**IEEE P802.15**  
**Wireless Personal Area Networks**

Project	IEEE P802.15 Working Group for Wireless Personal Area Networks (WPANs)	
Title	<b>TG3 LB19 comment resolution</b>	
Date Submitted	[24 October, 2002]	
Source	[James P. K. Gilb] [Apparent Technologies] [9921 Carmel Mountain Rd. #247, San Diego, CA 92129]	Voice: [858-538-3903] Fax: [858-538-3903] E-mail: [gilb@ieee.org]
Re:	[]	
Abstract	[This document is a record of comment resolutions for LB19.]	
Purpose	[To provide a record of the comment resolution for LB19.]	
Notice	This document has been prepared to assist the IEEE P802.15. It is offered as a basis for discussion and is not binding on the contributing individual(s) or organization(s). The material in this document is subject to change in form and content after further study. The contributor(s) reserve(s) the right to add, amend or withdraw material contained herein.	
Release	The contributor acknowledges and accepts that this contribution becomes the property of IEEE and may be made publicly available by P802.15.

Figure 7—MSC for SPS set creation command

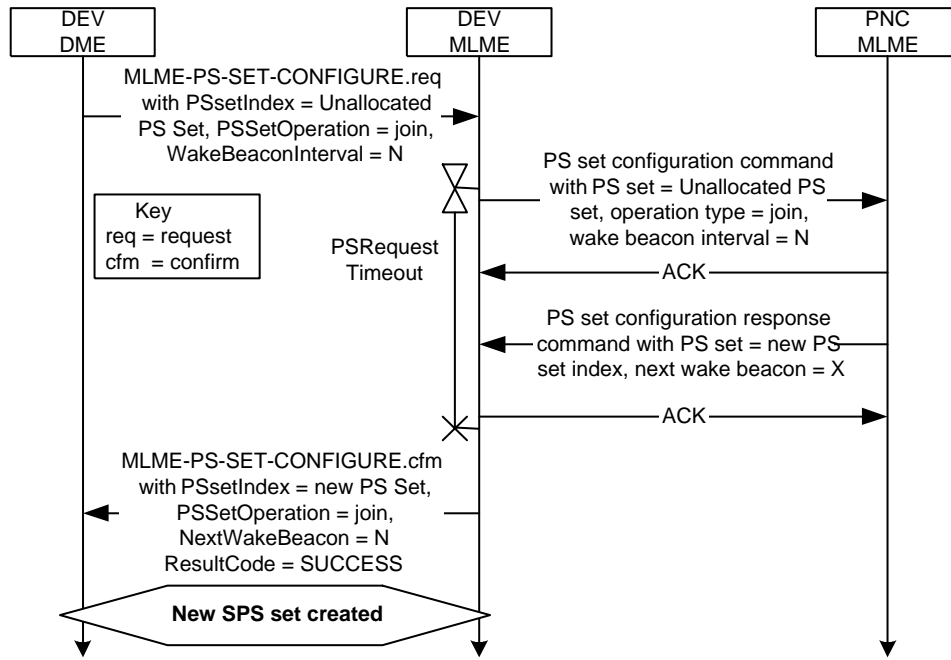
Figure 7 illustrates the message flow for a DEV requesting the creation of a new SPS set.

Figure 19—PNC handover MSC

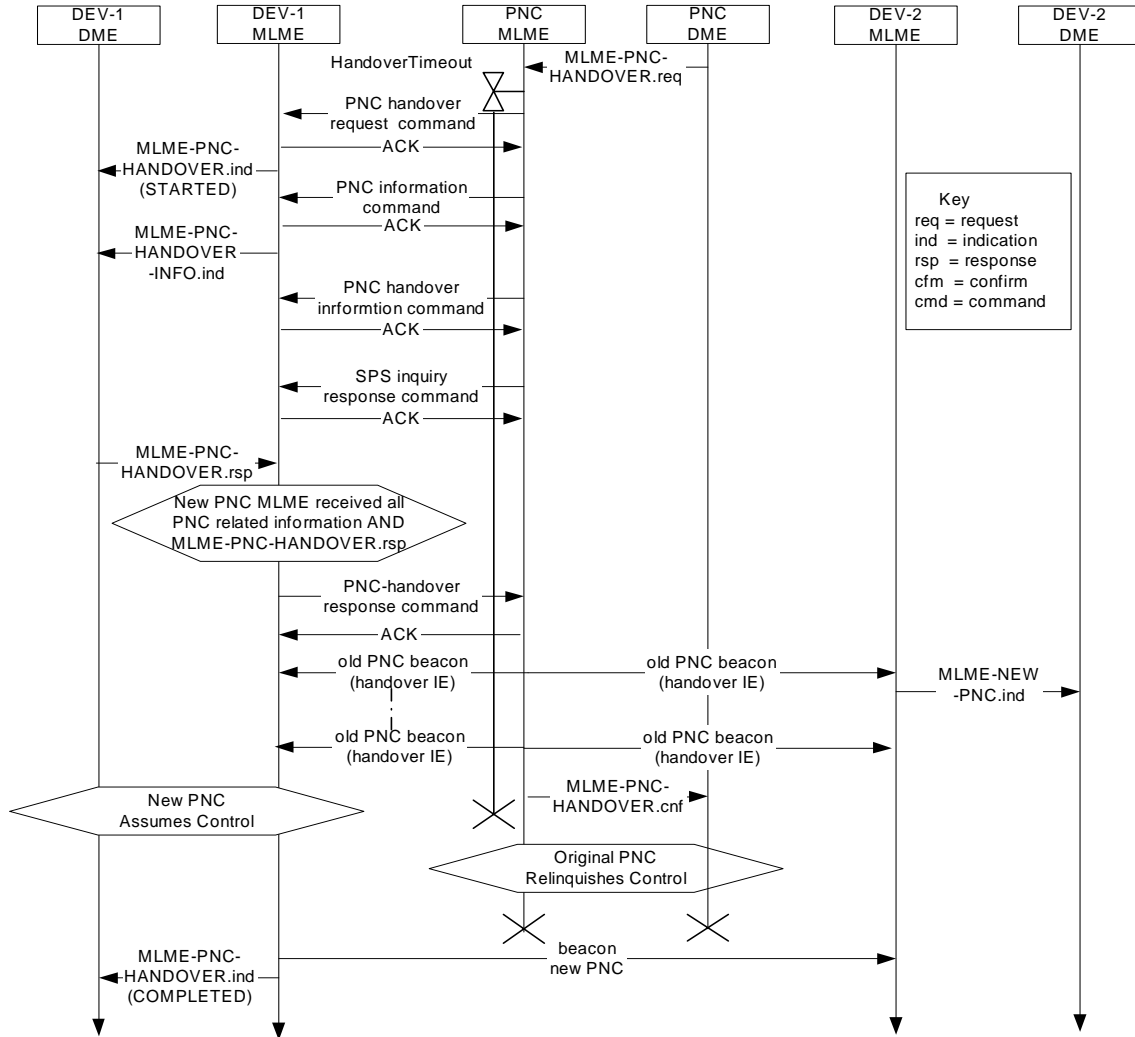
269 (Heberling, TR) - [PNCHndOvr] Some errors in text remain or were introduced after LB17.MSC in Figure 91 is also wrong./KO Text changes for 8.2.3 and ne MSC for Figure 91 are all collected in:02276r7P802-15\_TG3-commentsD11\_KO.doc, Resolution [03]. **Suggest accept in principle**, “The MSC will be modified as indicated in the resolutions of CID 58 and 232. Make the following text changes: In 6.3.13.4, page 59, line 45, change ‘This primitive informs the originating DME its request for information from the PNC is complete.’ to be ‘This primitive informs the DME that the MLME has received a PNC information command, {xref 7.5.4.2}.’ In 7.5.3.1, page 138, line 20 ‘the number of information records to be transferred using the PNC information command frame(s).’ to be ‘the number of DEV information records, {xref PNC handover info command}, that will be transferred from the old PNC to the new PNC.’ In 8.2.3 PNC Handover, delete page 156, line 8-9, redundant, same text in paragraph below. Add to page 156, line 19, ‘The PNC handover information command shall not be sent if the PNC has indicated in the PNC handover request command that it does not have any CTRBs to transfer.

The SPS inquiry response command shall not be sent if the PNC has indicated in the PNC handover request command that it doesn’t have any SPS sets to transfer.’

Add to page 156, line 35, ‘The new PNC shall broadcast its first beacon at the time the beacon would have been sent by the old PNC. This time may vary from the actual time due to clock inaccuracies of old and new PNCs. The new PNC shall start sending beacons with the beacon number counter set to one more than the beacon number of the last beacon that will be sent by the old PNC.’

Add page 156, line 40ff, ‘The PNC shall ensure that the beacon countdown includes at least one system wake beacon and at least aMaxLostBeacons beacons following that system wake beacon. The only exception to this requirement is if the PNC will be shutting down and does not have enough time to to wait for the next system wake beacon to complete the handover process. {Ed. note: This line may be moved to a new 8.1.1 that describes all beacon announcements.’}

**Figure 21—Illustration of bit ordering for data payload and text fields.**

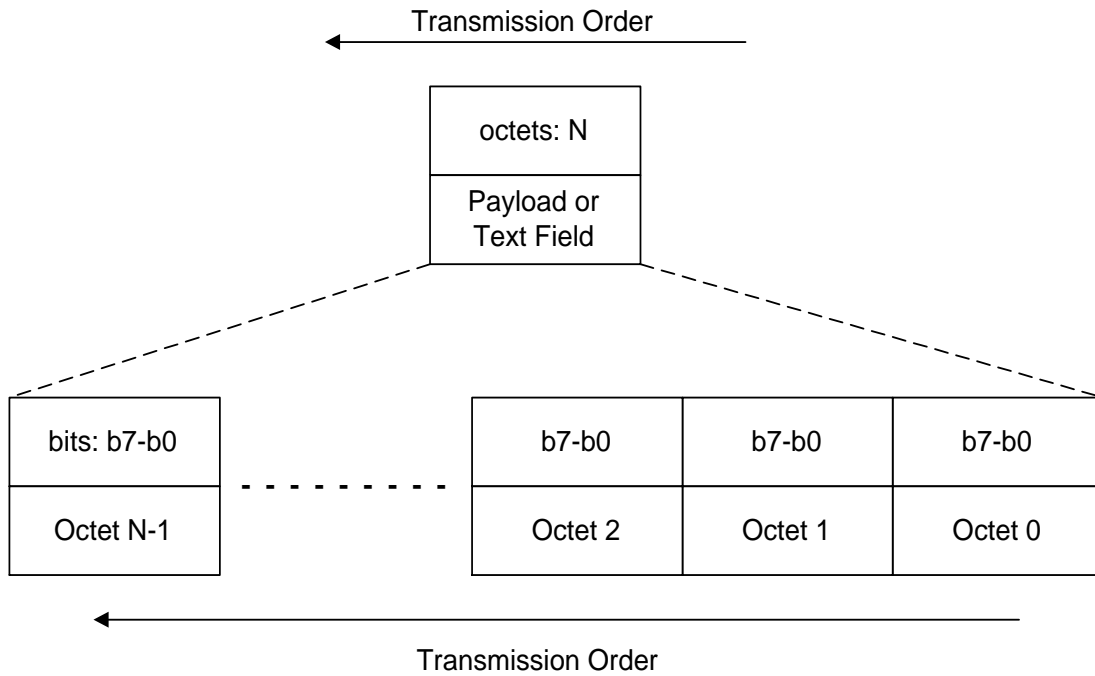
192 - ACCEPT IN PRINCIPLE. Add ‘The payload in the data frame is sent with the lowest numbered octet first, least significant bit first, over the air.’ to the beginning of line 51. After ‘the highest numbered bits.’ add ‘For any text fields, the first character is in the first octet of the field with other characters following sequentially.’ Also add a new figure for the data payload from 02/392r14.

345 - ACCEPT IN PRINCIPLE. Add ‘The payload in the data frame is sent with the lowest numbered octet first, least significant bit first, over the air.’ to the beginning of line 51. After ‘the highest numbered bits.’ add ‘For any text fields, the first character is in the first octet of the field with other characters following sequentially.’ Also add a new figure for the data payload from 02/392r4.
